BEFORE THE HAWKE'S BAY REGIONAL COUNCIL

IN THE MATTER of an application by **RAVENSDOWN LIMITED** (Ravensdown) for new and replacement water and discharge permits for the operation of the Napier Works and the establishment of a habitat enhancement project.

**MEMORANDUM OF COUNSEL FOR RAVENSDOWN REQUESTING A
DIRECTION THAT EXPERTS CONFERENCE**

26 MAY 2022

Figure 1.1: Comparison of SO₂ emission rates with the uncorrected and corrected gas flow rates for the period January 2016 to 1 August 2021.

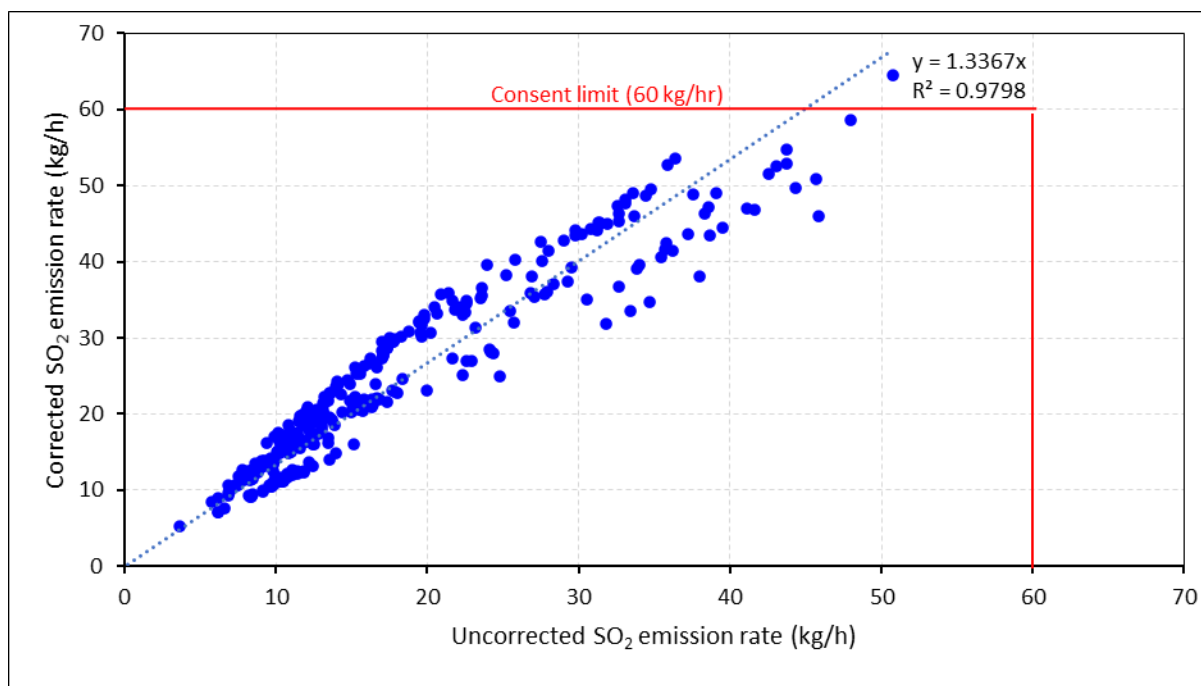
1 Please provide further information on the issue with the acid plant discharge flowrates, including updated information identifying when the calibration issue occurred, and information to demonstrate whether emissions from the plant have been compliant with the limits in the resource consent.

- The in-stack flow meter was recalibrated using multi point calculations, i.e., using Chemetics calculations and manual flow measurements.
- The Chemetics calculation has now been included in the Ravensdown's regular stack emission testing procedures that will check the air flow against plant conditions.
- Chemetics calculation and historical plant data (only available from 2015) have been used to estimate the correct air flow, enabling the SO₂ emission rates presented in the Air Quality Assessment to be corrected.

A comparison of the uncorrected and corrected SO₂ emission rates for the period from 2015 is presented in Figure 1.1 and Figure 1.2. This shows that the SO₂ emissions have complied with the limit of 60 kg/hr with the exception of a single result. Given this finding, and that no change is proposed to the emission rate limit of 60 kg/hr (until such time that the new converter is commissioned), the assessment against 1-hour and 24-hour assessment criteria presented in the T+T Air Quality Assessment remains appropriate.

Figure 1.1 provides an updated timeseries plot to that that given in the T+T Air Quality Assessment (Figure 3.2), that includes the corrected emission rates. Figure 1.1 also presents the 75th percentile values for the corrected and uncorrected SO₂ emission rates, which shows an increase from 18.7 kg/hr to 28.1 kg/hr. This revised value of 28.1 kg/hr has been used in an updated dispersion modelling assessment to predict annual average SO₂ ground level concentrations, as discussed in section 4 below.

Figure 4.1: Analysis of measured 1-hour average SO₂ concentrations by wind direction that associated with normal Acid Plant start-up. Values represent concentrations measured in the preceding 5 days prior to sulphur being introduced into the burner.

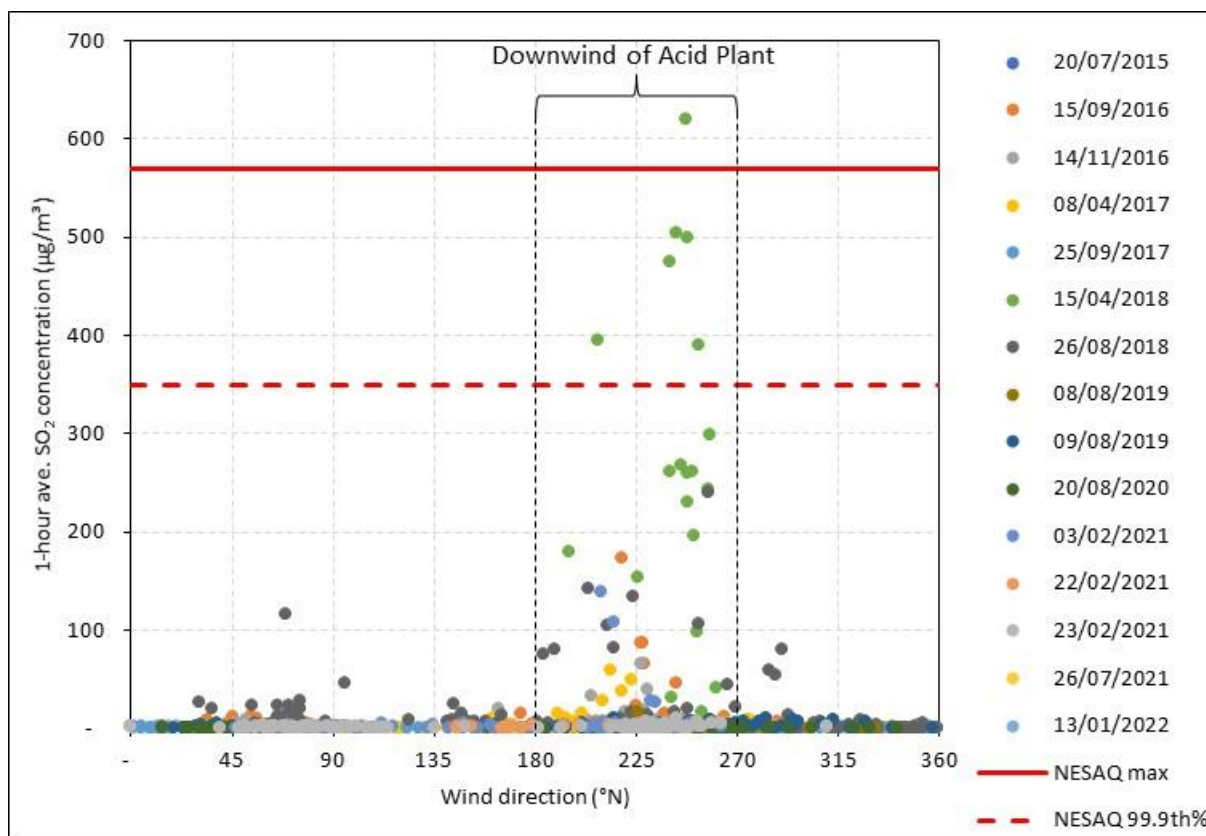
4. Please update the section on ambient monitoring of sulphur dioxide to clearly demonstrate the contribution from normal acid plant start-ups.

The measured SO₂ concentration during each start up period by wind direction is summarised in Figure 4.1. This analysis clearly highlights the period of high concentrations that occurred on 11 April 2018 during a start-up, which is discussed in Section 5.3 of the T+T Air Quality Assessment. As noted in the report, the cause of this issue was identified as being due to the then use of a 3 m high temporary stack that was fixed to the furnace during pre-heating of the furnace. This was addressed by the installation of a permanent 13 m high stack during the 2018 winter shutdown. Other protocols associated with both plant shut-down and start-up have also been implemented. Concentrations during start-up have been significantly lower since these measures were implemented.

This analysis demonstrates that Acid Plant start-ups have not been responsible for peak concentrations of SO₂ measured at the former Winstone monitoring site since the measures implemented during the 2018 winter shutdown period.

Figure 1. TANK PC9 Awatoto and Taradale SPZ map showing the Project Area (source: HBRC).

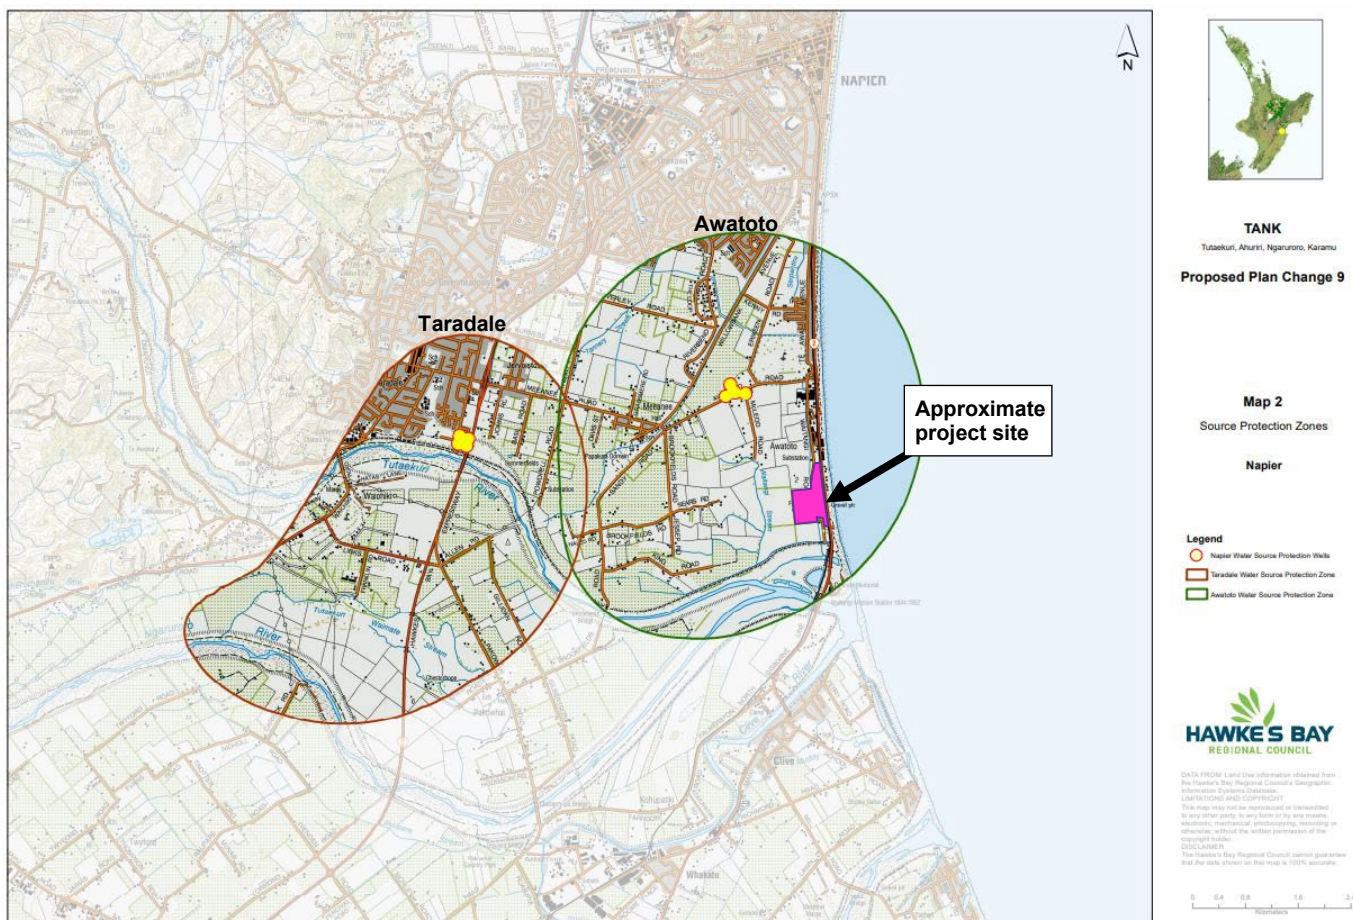
- 34. Provide a map of the SPZs with the full site boundary including the land discharge area. The names of the SPZs and distances from or if the site is included within a SPZ should be provided in the Appendix and where relevant in existing text that refer to the SPZ, notably the Executive Summary.*
- 35. Please consider and provide commentary on the revised well locations (refer Figure 10 below with recommended locations) and increase the number of sampled monitoring wells to all three wells.*

The HBRC proposed TANK Plan Change 9 (PC9) provides maps of Source Protection Zones (SPZ) across the region. The Awatoto and Taradale SPZ's, and the Napier Water Source Protection Well sites are displayed in Figure 1 along with the approximate Project Area. The Napier SPZ's are also now discussed in Section 3.3 of the Report with a map included in Appendix B.

Figure 3. Proposed Monitor Well Locations as suggested by Mott McDonald.

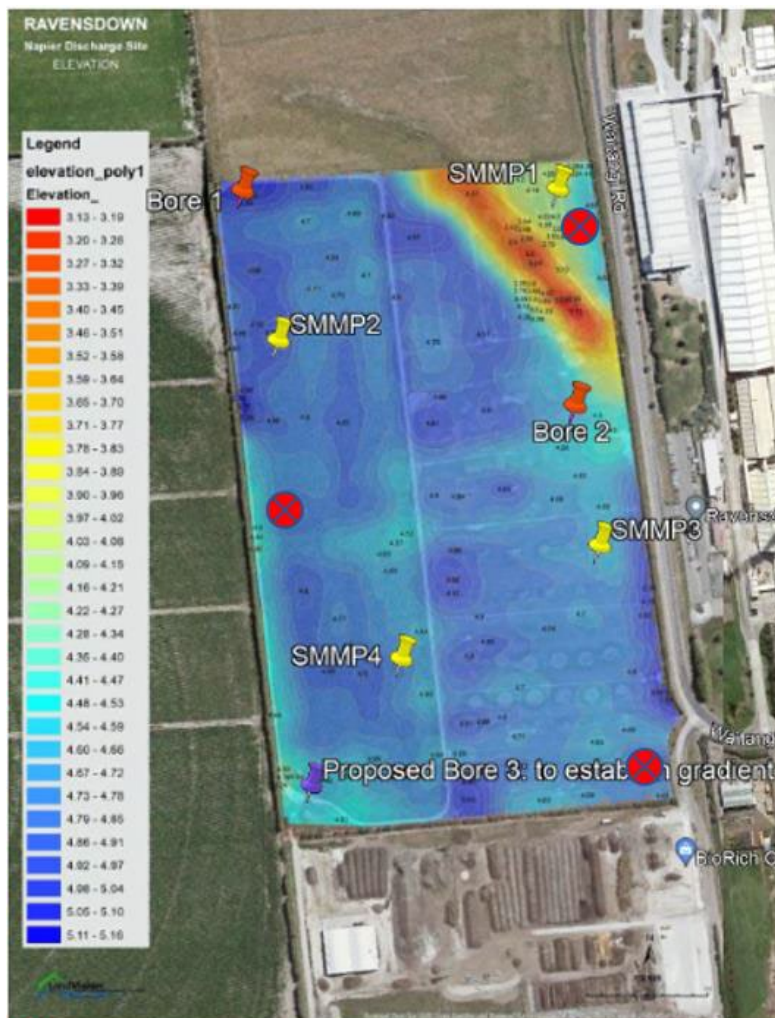
35.	Please consider and provide commentary on the revised well locations (refer Figure 10 below with recommended locations) and increase the number of sampled monitoring wells to all three wells.	Attachment 7 - Bay Geological Services Ltd, 20 April 2022

The locations for the Monitor Bores as proposed by MM are generally accepted, but it is suggested that two of the proposed Monitor Bores are drilled to establish the hydraulic gradient (using the BioRich data) prior to the remaining Monitor Bore being drilled.

Figure 4. Tidal Influence Assessment across the Heretaunga Plains showing Project Site (PDP, 2014)

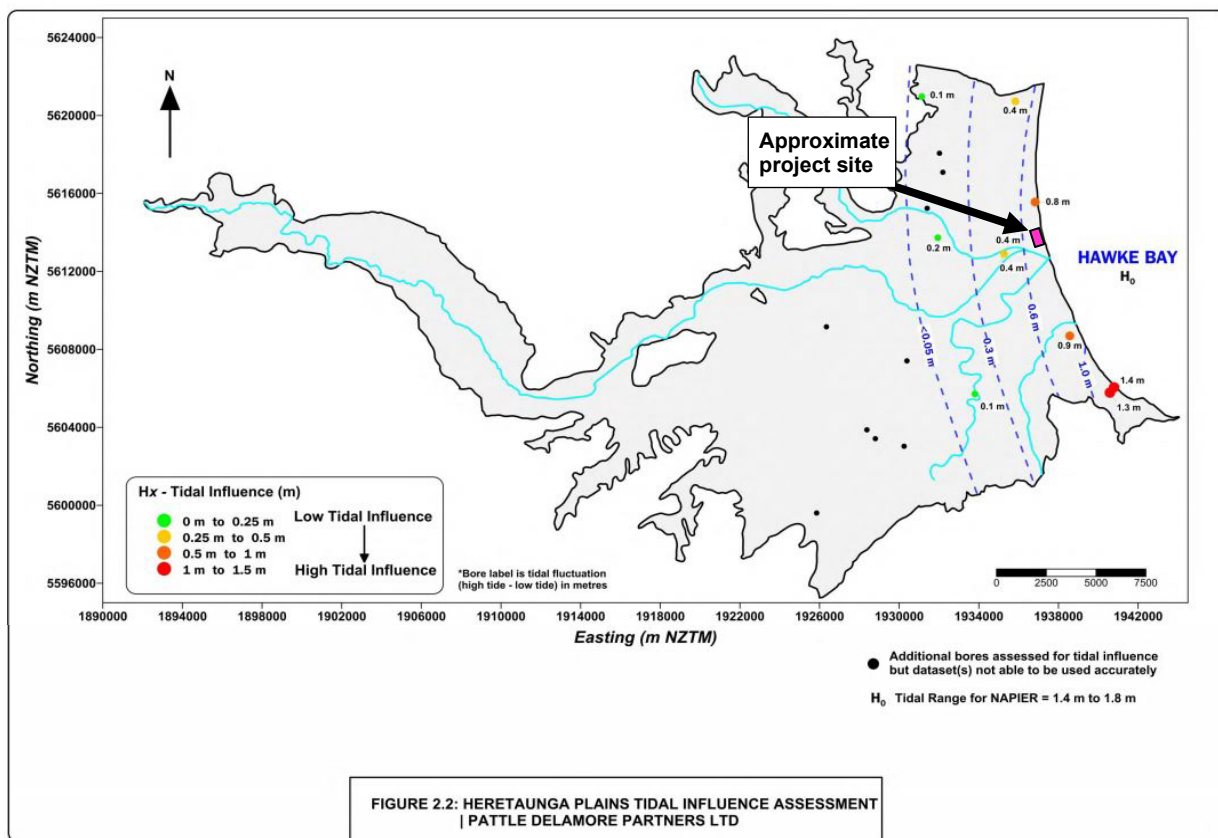
37.	Please provide saltwater intrusion risk assessment.	Attachment 7 - Bay Geological Services Ltd, 20 April 2022
A8: ECONOMIC ASSESSMENT (Mott MacDonald, 3 Mar 2022) <i>No review of pre application draft</i>

A client report for HBRC completed by PDP (2014) reviews the effect of tides on groundwater wells along the Hawkes Bay coastline. An approximate 12-hourly sinuous response is typically noted in pump test data collected from coastal bores, and the PDP (2014) study deduced that measurable groundwater fluctuation as a result of tidal flux is observed at approximately 6 km from the coast (refer Figure 1). The Applicant's Production Wells are located approximately 100 m west of the Mean High-Water Springs (MHWS), and when applying the tidal effect contours determined by PDP (2014), an effect of >0.6 m and inferred as <1.0 m is predicted as a response to tidal flux within the vicinity of the site.
